SEI HAM ECR-002

ENGINEERING CHANGE REQUEST (ECR)

NEXT ASSEMBLY NO. D 972613

DRAWING TITLE LIGO HAM Support Tube Mounting Base

CUSTOMER DRAWING NO. D 972613

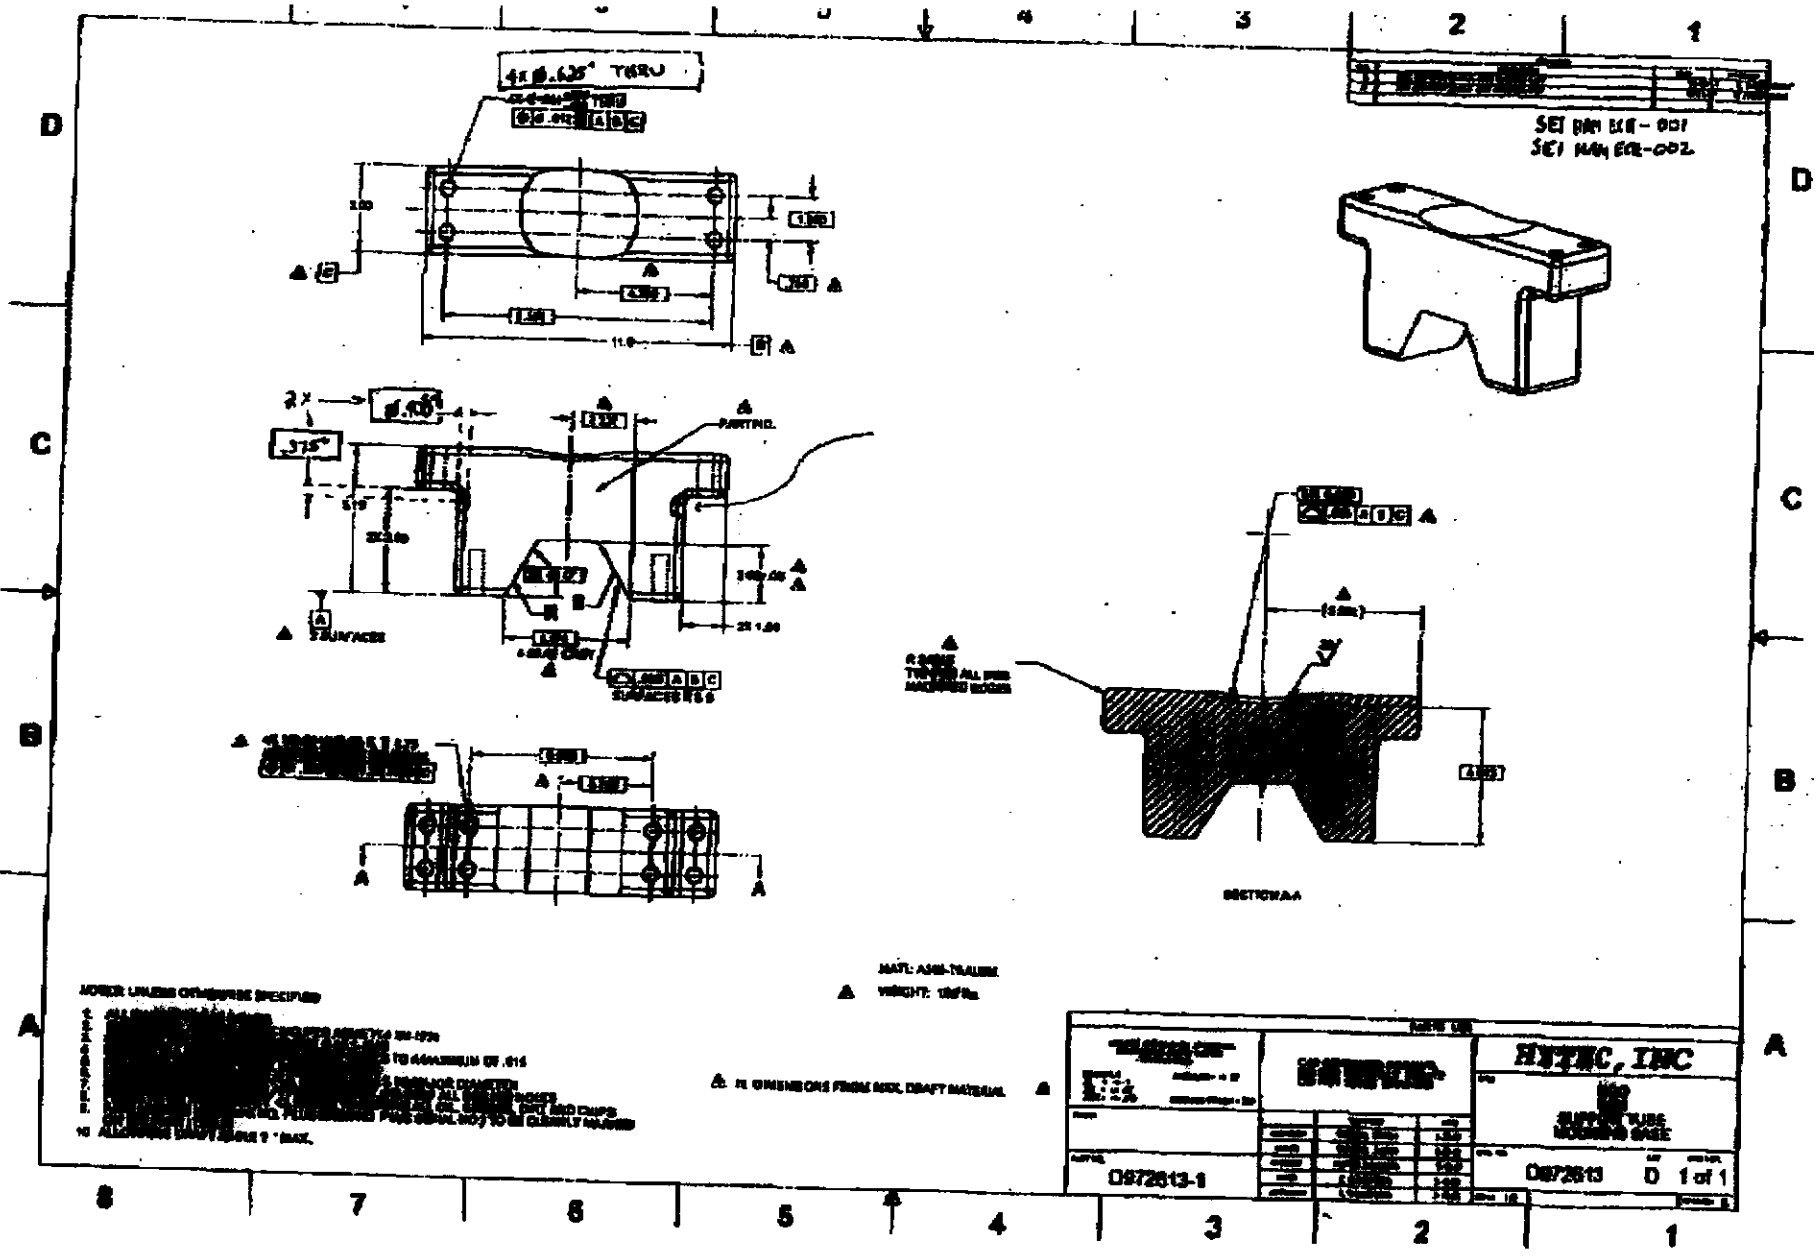
With 3/4" ball end mill, ~~is~~ made cut with .375 radius
.400 deep. (see drawing)

Give clearance for bolt heads.
